CITY PLAN COMMISSION/ARCHITECTURAL REVIEW BOARD
VIRTUAL ZOOM MEETING
MONDAY, AUGUST 17, 2020
17:30 (05:30 PM)

7700 BONHOMME AVENUE – ARCHITECTURAL REVIEW BOARD – SIGNAGE

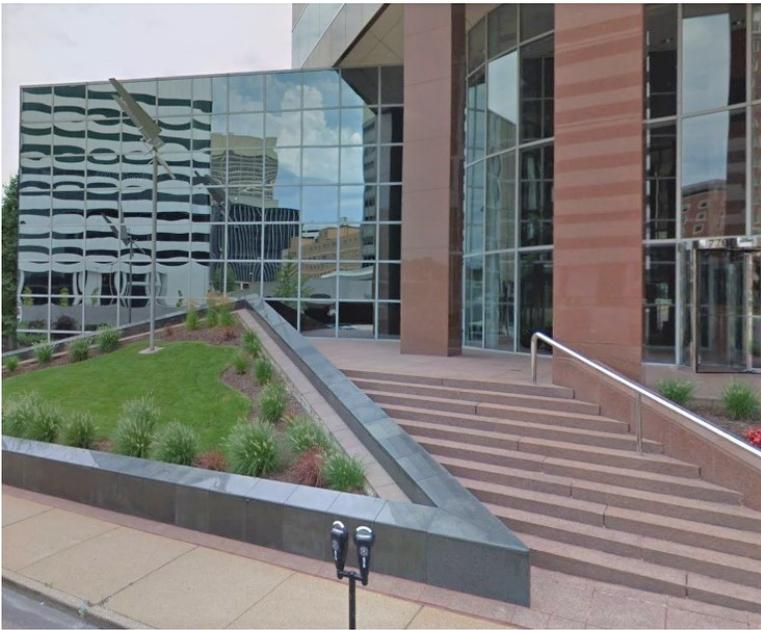
The following signage appeared on the building in the same location, but no permit was issued by the City; it was there from approximately 2015 to 2020. Staff estimates the size of the signage was approximately 10 feet wide x 3.5 feet in height for a total area of approximately 35 square feet.

The present building appearance (no sign, Bonhomme frontage):

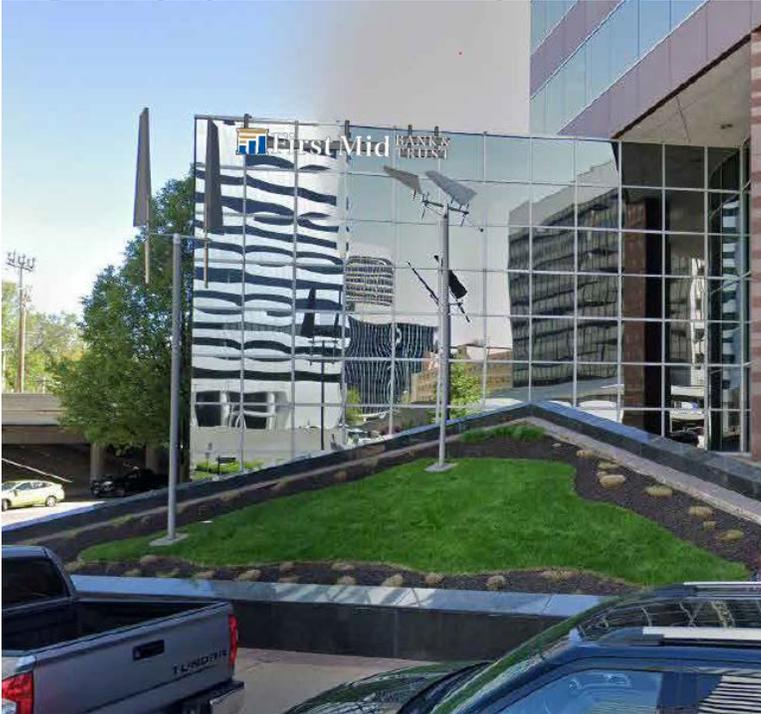
requires a 4-foot setback from the corner of the building. No measurements were provided with the drawings however a field inspection revealed that each glass panel comprising the building is approximately 4 feet in height and width, therefore it appears that the proposed Bonhomme facing sign does not meet the required 4-foot setback requirement from the corner of the building.

Staff is of the opinion that the proposed material and sign color is compatible with the building and surrounding character. As to the proposed location, the code requires the sign to be located at or near the first-floor ceiling level, whereas these signs are proposed to be located at the top of the building. At least one previously approved sign (Charles Schwab) was in the same location albeit both former signs (Schwab and Edwardsville Bank) were in a similar location and the Bonhomme facing sign was not centrally located on the building façade.

Staff would like to see the sign reduced in area, so the signs scale aligns more closely with the scale of the glass portion of the building upon which it is located, and the scale of the existing ground sign located along the Hanley Road frontage.

1. THE MAXIMUM ALLOWABLE SIGN AREA, PER SIGN, SHALL BE 40 SQUARE FEET.
 2. THE SIGN ALONG BONHOMME AVENUE SHALL BE SET BACK 4 FEET FROM THE CORNER OF THE BUILDING.”
-
